Date: April 10, 2018

From: Lucy Sloman, DSD Land Development Manager
Michelle Wright, DSD Engineer

Subject: Briefing Response Memo for Westridge North Single-family Plat
PP17-00001 | PRJ17-00016

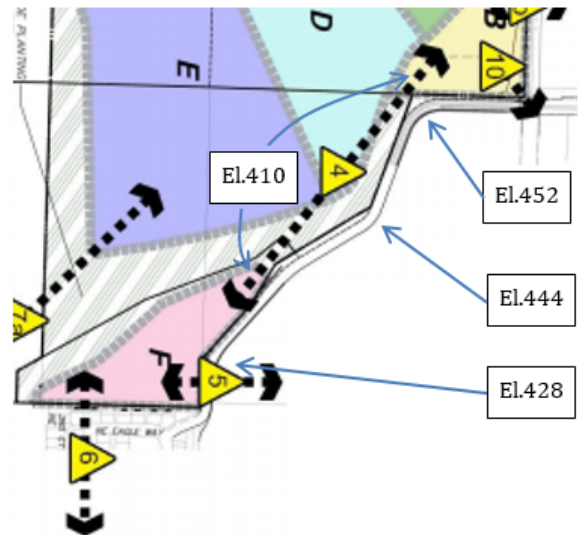
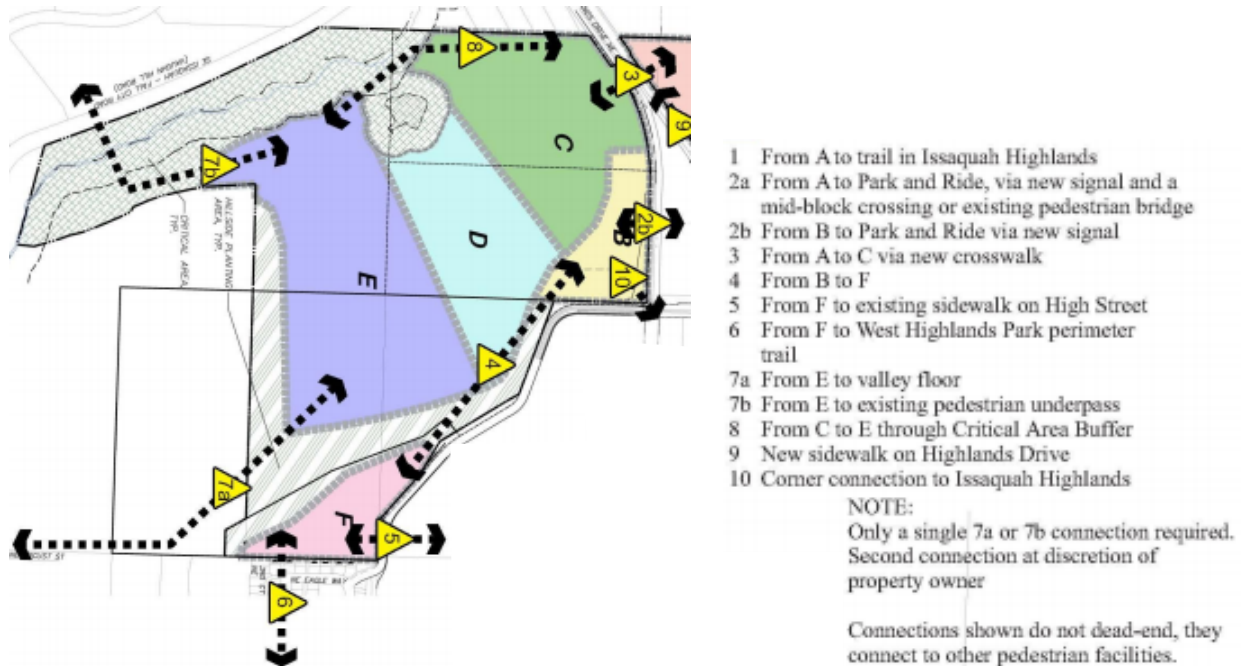
Lakeside connections: [Trails referenced are shown on the Lakeside Development Agreement map at right and below.] It is accurate that the Lakeside trail #4, connecting Lakeside Neighborhoods B to F, will mostly parallel High Street; however, this trail may not be built for 15 to 20 years. Additionally, due to the elevation differences and connection points, it will not be as convenient as High St multi-use trail for serving as a broader community resource. That is, it is 20-40 vertical feet below the High St multi-use trail. That means that the Lakeside trail will be less convenient for users that are moving through the Issaquah Highlands community. It will also be significantly less direct.

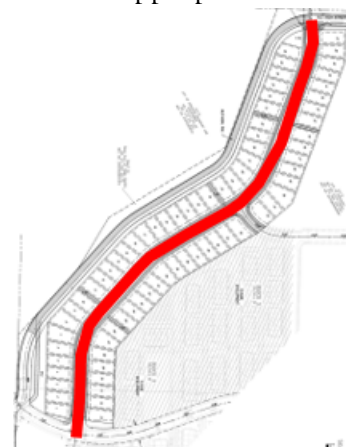
We have no confidence in the future product. Why is this asphalt? This isn’t a new trail.

Aesthetically, asphalt isn’t nice. Make this concrete. This shouldn’t look and feel like a road when this is done.

Add a NEW Condition #38: "The High St multi-purpose trail will be ground down and overlaid with trail grade asphalt, special paving and markers integrated at nodes such as street intersections,

and street furniture, plantings, and wayfinding that comprehensively create a linear community space.”

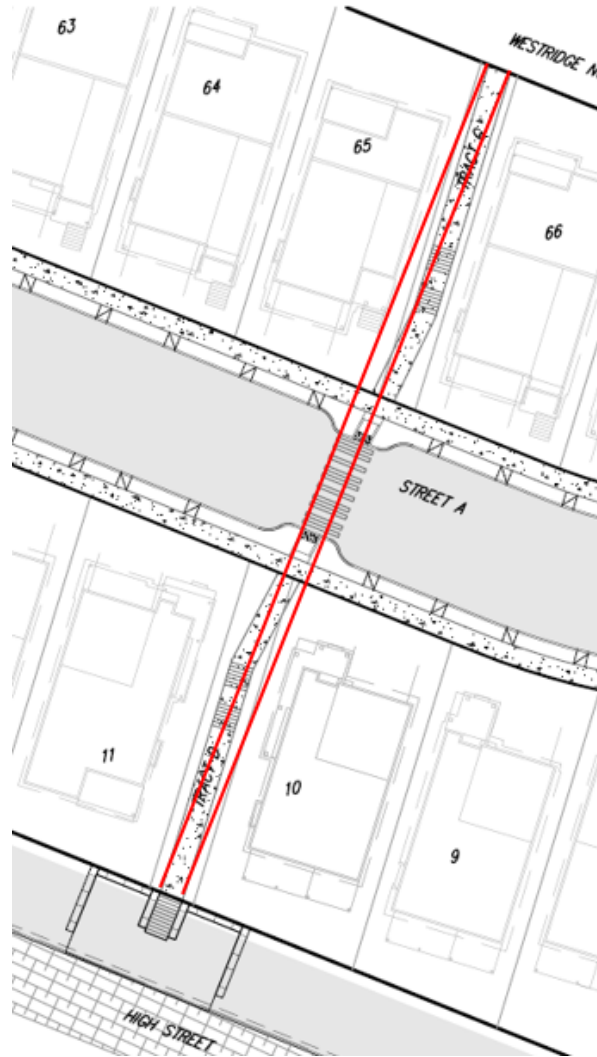
Why don't they line up? Why can't you swap lots of different sizes to get them to line up? What would it take?

The annotations to the applicant's drawing below illustration some of the challenges they face in providing sightlines and landscape borders consistent with proposed Approval Condition #24, while retaining the angle of the homes which fulfills House & Garden guidelines.

"#24: Align the trail in Tracts D and G, so that there is a direct, clear, and visually connected trail network between Block 2 and the High St multi-use trail. Maximum offset will be half the trail standard's width. If the trail is angled within the tracts to achieve this, the landscape border may go below the minimum on one side as long as the total width of landscape border equals the total required border and the reduced landscape border does not go below 2 ft. This will be reviewed with the Final Plat and construction permits."

Applicant: The homes are sited at an angle to the plat road, not perpendicular. This presents a little more architectural exposure and reduces the garages lining up on the same set back line. When the trail crosses Street A in a perpendicular manner, we need to eventually angle it to get out through the rear of the lots to the Townhomes North side and the High Street side. We adjusted the trail to have a 90+ foot straight sightline across Street A. To make the trail perfectly straight is a challenge while retaining the angle of the homes. In addition, pedestrian bulb-outs are provided to calm traffic and provide pedestrian visibility. See below for revised walk alignment.
